Access Compliance Report

Public Rights-of-Way (Curb Ramps)

Intersection ID: 7211	Main Street: KINGVILLE_DR	Cross Street: NORTHRIDGE_VILLAGE_DR	Location: SE
ADA ID: 5A0FB91FC983	Ramp Type: Directional1	Initial Pass/Fail: Fail	Overall Compliance: No
		Severity Score: 22.5

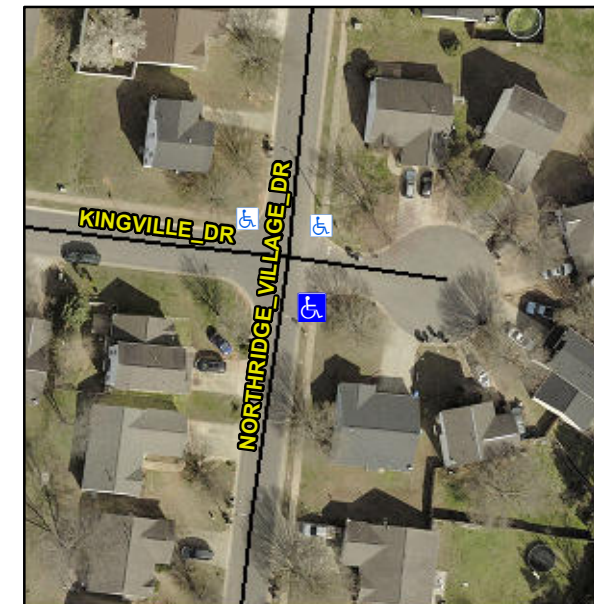
R304.5.1, R304.2.2, R304.5.3

Compliance	Description	Data	Compliance	Description	Data
N/A	Ramp Length (in)	16.5	N/A	Grade Break?	N/A
No	Ramp Width (in)	47.0	N/A	Grade Break Slope (%)	0.0
No	Ramp Slope (%)	10.8	N/A	Grade Break XSlope (%)	0.0
No	Ramp XSlope (%)	3.3			
N/A	Flare Type LT	N/A	N/A	Flare Type RT	N/A
N/A	Flare Slope LT (%)	N/A	N/A	Flare Slope RT (%)	0.0
N/A	Flare Traversable LT?	N/A	N/A	Flare Traversable RT?	N/A
N/A	Landing Length (in)	0.0	N/A	DWS Provided?	N/A
N/A	Landing Width (in)	0.0	N/A	DWS Contrast?	N/A
N/A	Landing Slope (%)	0.0	N/A	DWS Length (in)	N/A
N/A	Landing X Slope (%)	0.0	N/A	DWS Full Width?	N/A
N/A	Landing Curb? (Y/N)	N/A	N/A	DWS Offset LT (in)	N/A
N/A	Shared Landing?	N/A	N/A	DWS Offset RT (in)	N/A
N/A	Gutter Ponding?	Yes	N/A	Gutter Slope (%)	N/A
N/A	Gutter Lip Ht (in)	0.0	N/A	Gutter X Slope (%)	N/A
N/A	Painted X Walk1?	No		Road Slope (%)	0.4
	X Walk 1 Direction	To NE		Road X Slope (%)	1.7
	X Walk 1 Width (in)	N/A		Clear Space?	N/A

Remove & Replace Entire Ramp.
